REVISED RESPONSE TO REQUEST FOR ADDITIONAL INFORMATION

APR1400 Design Certification

Docket No. 52-046

RAI No.: 141-8098
SRP Section: 12.03-12.04 - Radiation Protection Design Features
Application Section: 12.3
Date of RAI Issue: 08/07/2015

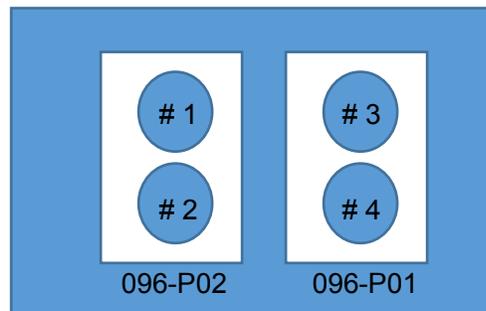
3. While the FSAR indicates that there are four gaseous radwaste system delay beds, it is unclear which rooms each delay bed is located. FSAR Table 12.3-4 indicates that Rooms 096-P01 and 096-P02 are delay bed rooms. Please specify in the FSAR which rooms each of the delay beds (1, 2, 3, and 4) are located.

2. As shown in DCD Figure 12.3-12, Room 063-P05 is the Spent Resin Long-term Storage Tank Room, and Room 063-P06 is a room for "Future Use". Therefore, Table 12.3-4 was updated to correct this discrepancy.
3. Two delay beds are located in a cubicle. The first and second delay beds are located in Room 096-P02, and the third and fourth beds are in Room 096-P01 as below;
